Committee of Experts on the Transport of Dangerous Goods and on the Globally Harmonized System of Classification and Labelling of Chemicals

Lithium battery test and definition of “rupture” in section 38.3 of the Manual of Tests and Criteria

Submitted by the Rechargeable Battery Association (PRBA) and the
Advanced Rechargeable & Lithium Batteries Association
(RECHARGE)

Figure 2
Battery with bulging (no cells exposed) would not meet definition of rupture

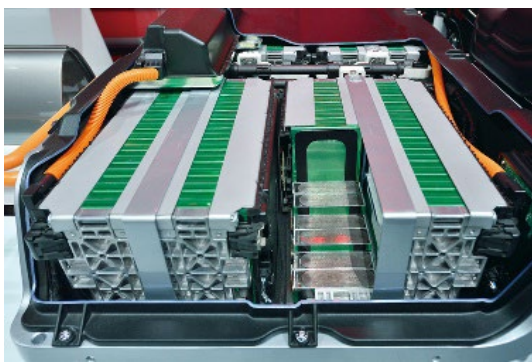
3. The text of the note is maintained, as a mean to help clarifying the definition word “exposure” used in the definition.
4. For a battery not fully enclosed by its casing, when a cover bulges or flexes from expansion, the already exposed internal cell components will be more exposed visually and it is unclear if this additional exposure would be interpreted as a rupture.

5. The note clarifies where the professional should focus their attention to determine whether there is a rupture or not after the test. It also clarifies that the mere fact of having cells exposed prior to the test is not a concern per se. The determination of the failure should be made on the base of the assessment of a change after test. The important question is: is it more exposed material fate the test, compared to the initial situation?

NOTE: In the case of a battery that is not fully enclosed by its casing and the cells are exposed by design prior to the tests, “exposure” means an increased visibility of components that are exposed beyond that of the original design of the battery.”
